TSG-RAN Meeting #6 **_TSGRP#6(99)676_**
Nice, France, 13 – 15 December 1999

Title: **Agreed CRs of category "D" (Editorial) to TS 25.211**

Source: **TSG-RAN WG1**

Spec	CR	Rev	Phase	Subject	Cat	Version-Current	Version-New	Doc
25.211	006	-	R99	Change to the description of TSTD for SCH	D	3.0.0	3.1.0	R1-99i47
25.211	008	1	R99	Modifications to STTD text (*1)	D	3.0.0	3.1.0	R1-99j26
25.211	010	-	R99	Update to AICH description	D	3.0.0	3.1.0	R1-99i49

~~**Figure 9: Multiplexing scheme of SCH (TSTD) and P-CCPCH (STTD).**~~

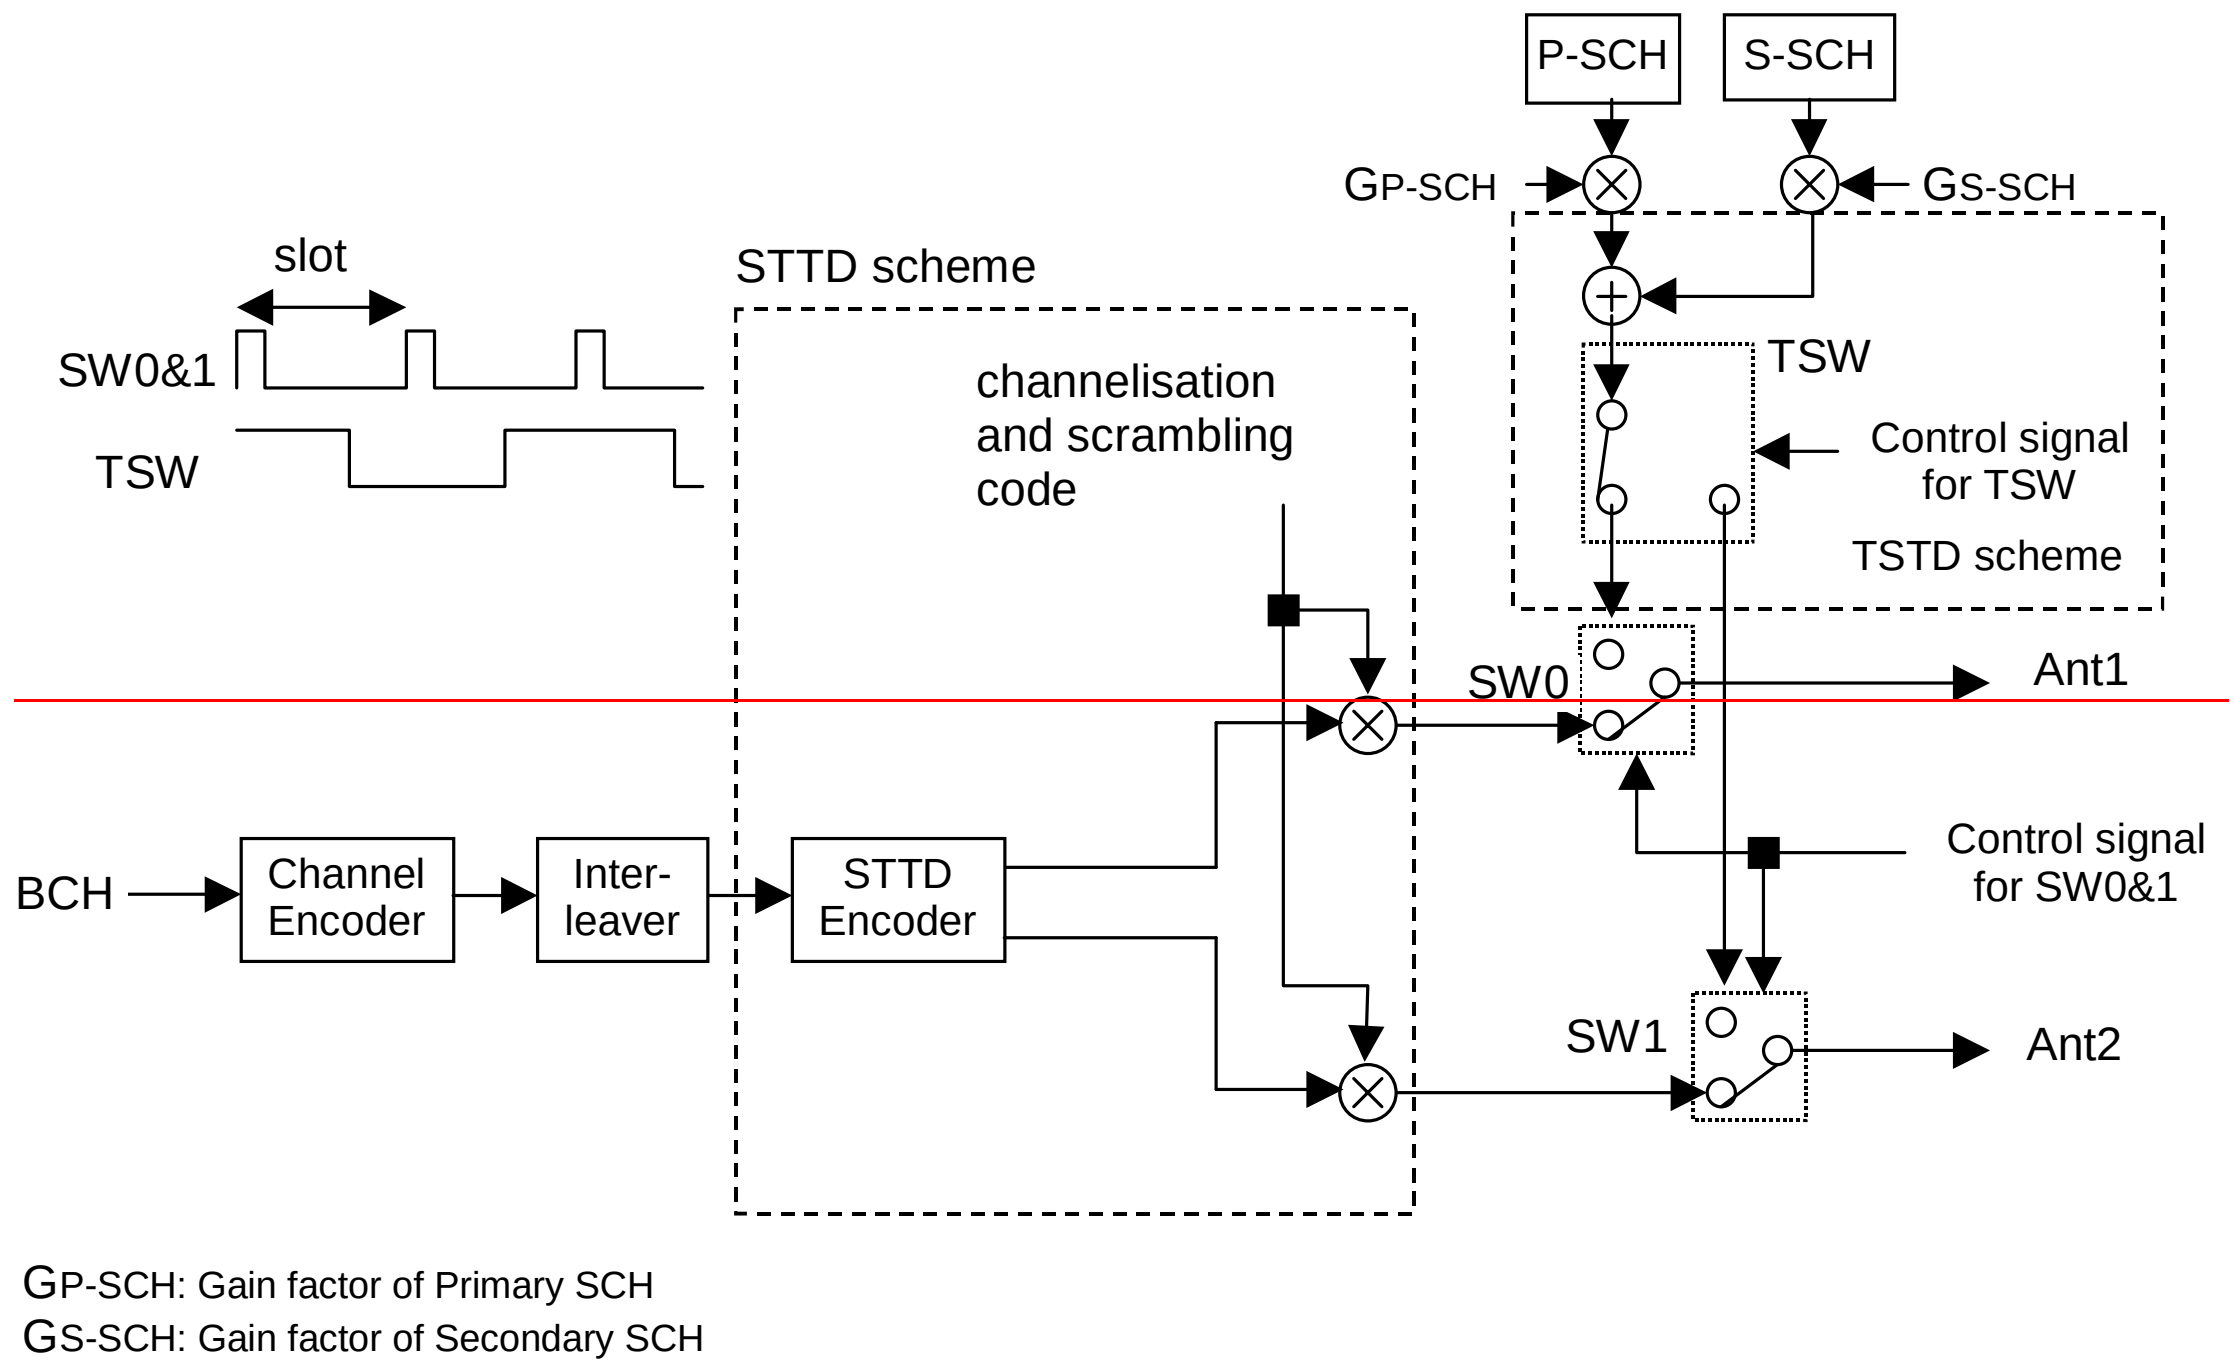
TSTD can be applied to the SCH. How this is done is specified in section 5.3.3.4.1 in TS 25.211. However, TSTD is also described, in a very non-specification like manner in the figure in section 5.3.1.1.2. Further, the figure is not very clear and can be misleading.

This CR removes the unnessecary figure and makes editorial updates to the text in TS 25.211.

Reason for change: The TSTD function for SCH is described in multiple places in TS 25.211. To remove this ambiguity, one figure is deleted and some editorial changes are made.

Transmit diversity, in the form of Time Switched Transmit Diversity (TSTD), can be applied to the SCH. TSTD for the SCH is optional in UTRAN, while ~~.~~TSTD support is mandatory in~~at~~ the UE. ~~A block diagram of the transmitter using TSTD for SCH and STTD for P-CCPCH is shown in Figure 9.~~TSTD for the SCH is described in sub-clause 5.3.3.4.1.

Figure 7: Generic b~~B~~lock diagram of the STTD encoder.~~transmitter (STTD)~~.

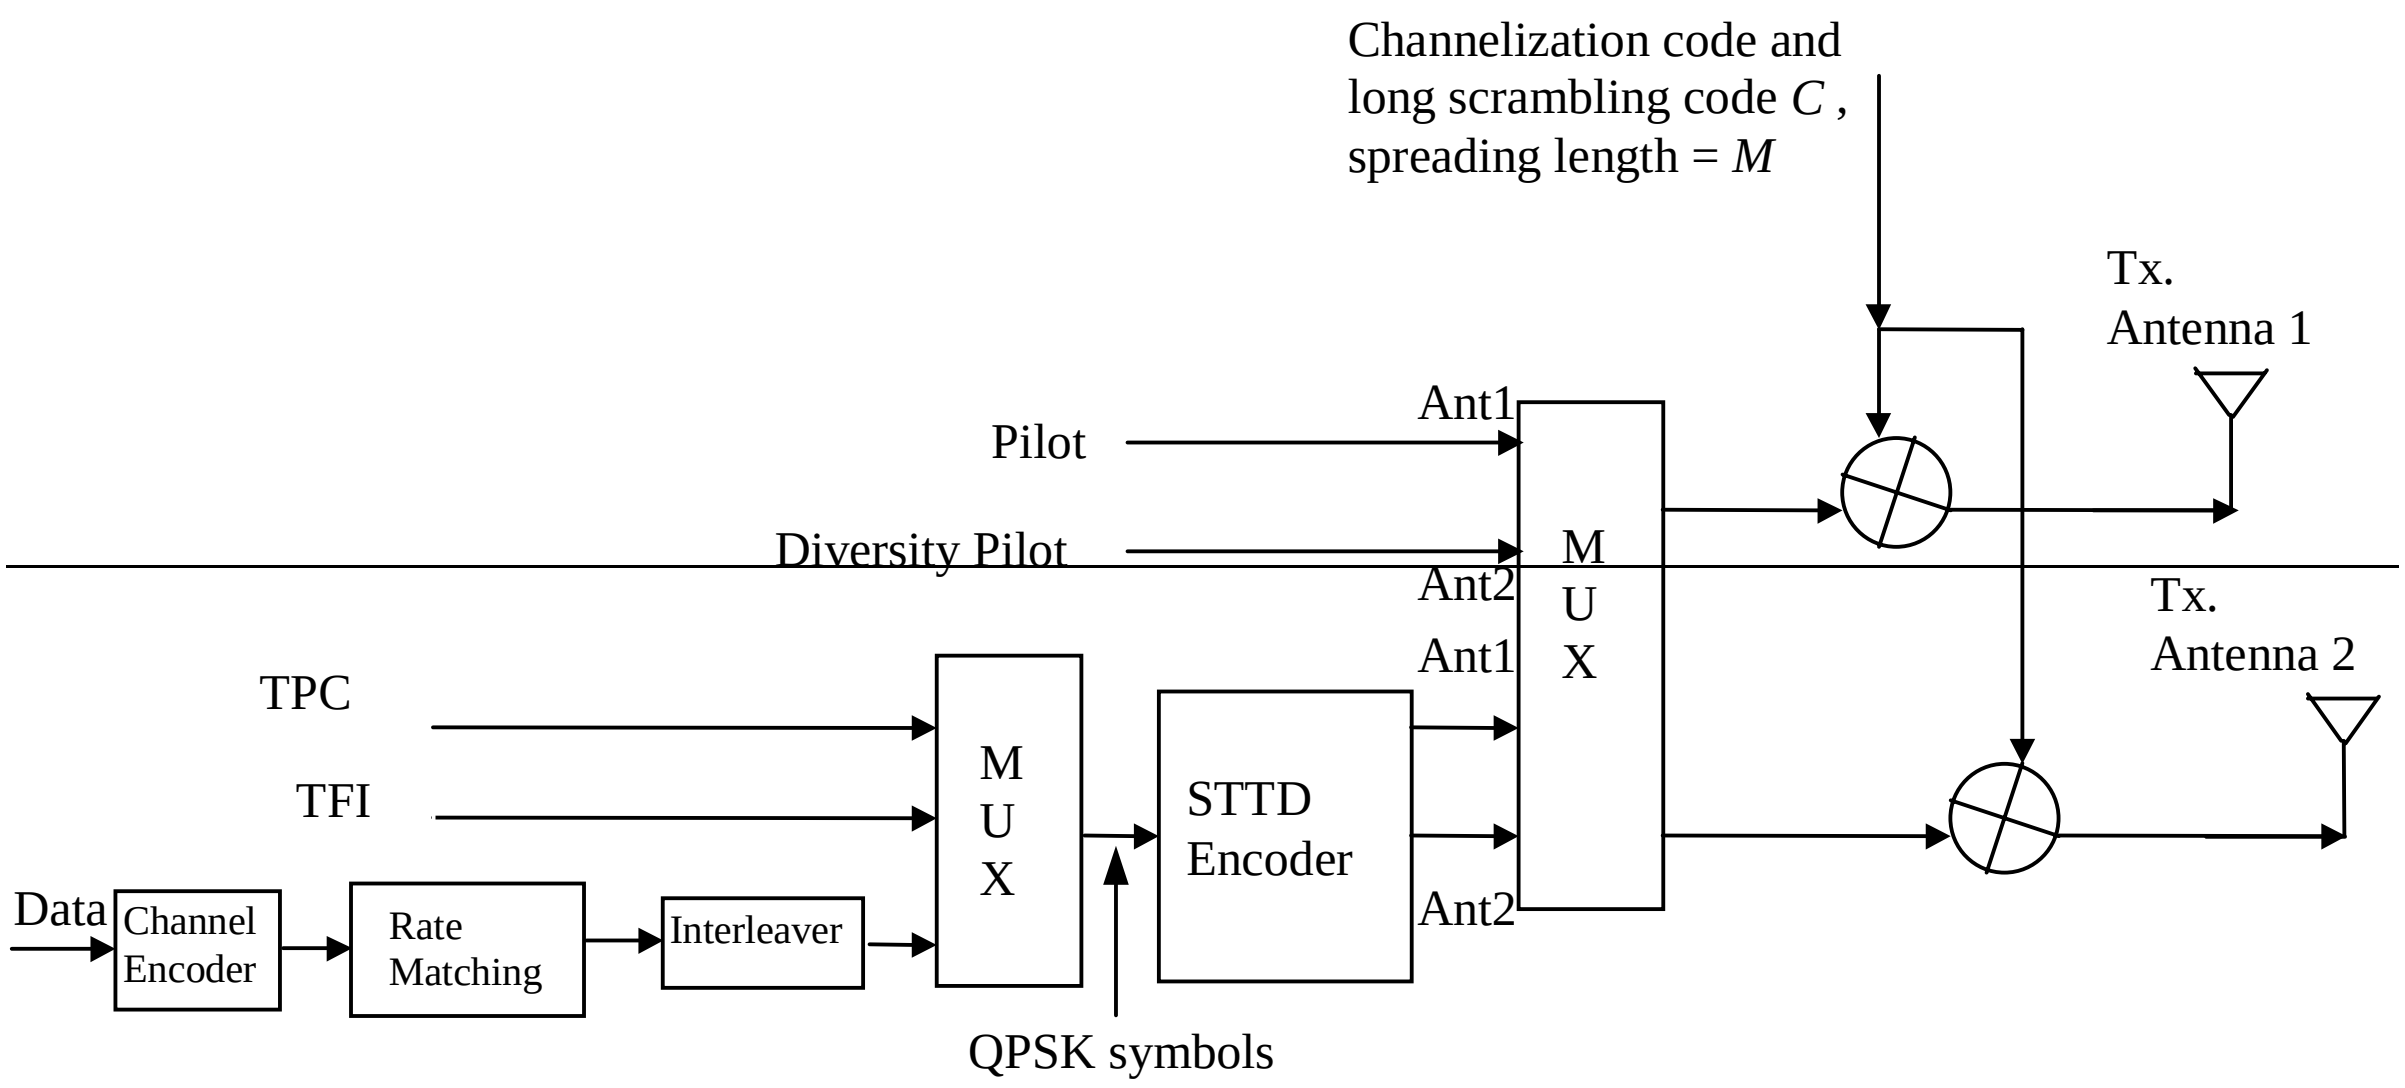
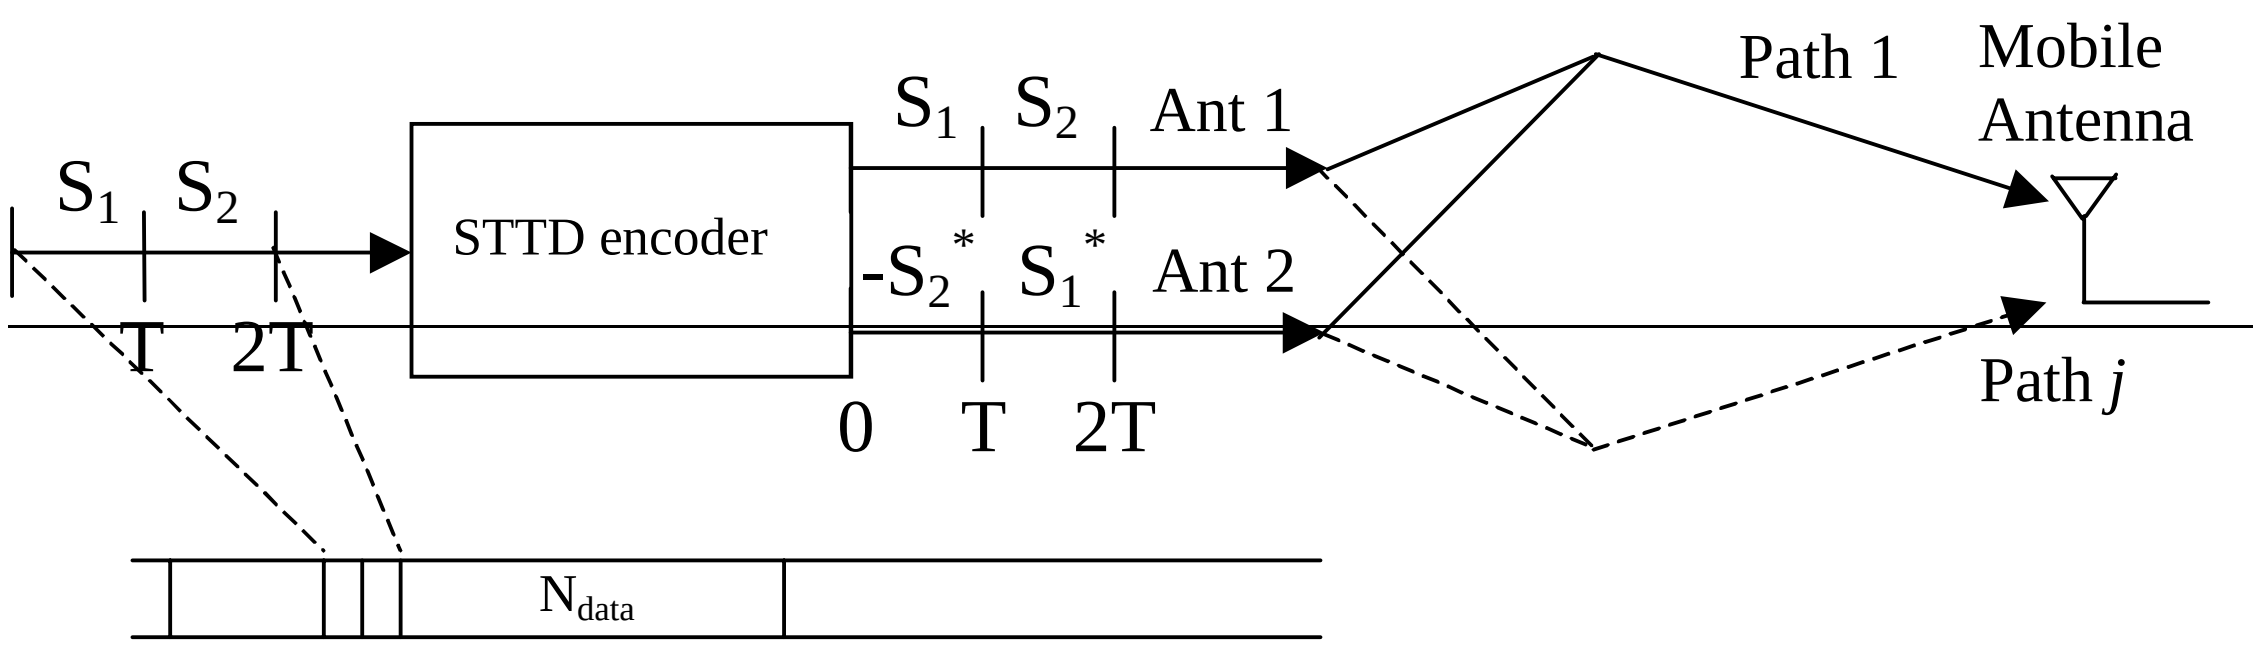
Reason for change: Better readability and notation for STTD description

The open loop downlink transmit diversity employs a space time block coding based transmit diversity (STTD). The STTD encoding is optional in UTRAN. STTD support is mandatory at the UE. A block diagram of ~~the transmitter and~~ a generic STTD encoder for channel bits b_0, b_1, b_2, b_3 ~~are~~ is shown in- Figure 7 ~~and Figure 8~~ below. Channel coding, rate matching and interleaving is done as in the non-diversity mode. The bit b_i is real valued {0} for DTX bits and {1, -1} for all other channel bits.

~~**Figure 8: Block diagram of STTD encoder. The symbols S_1, S_2 are QPSK or discontinuous transmission (DTX) symbols and T denotes the symbol time.**~~
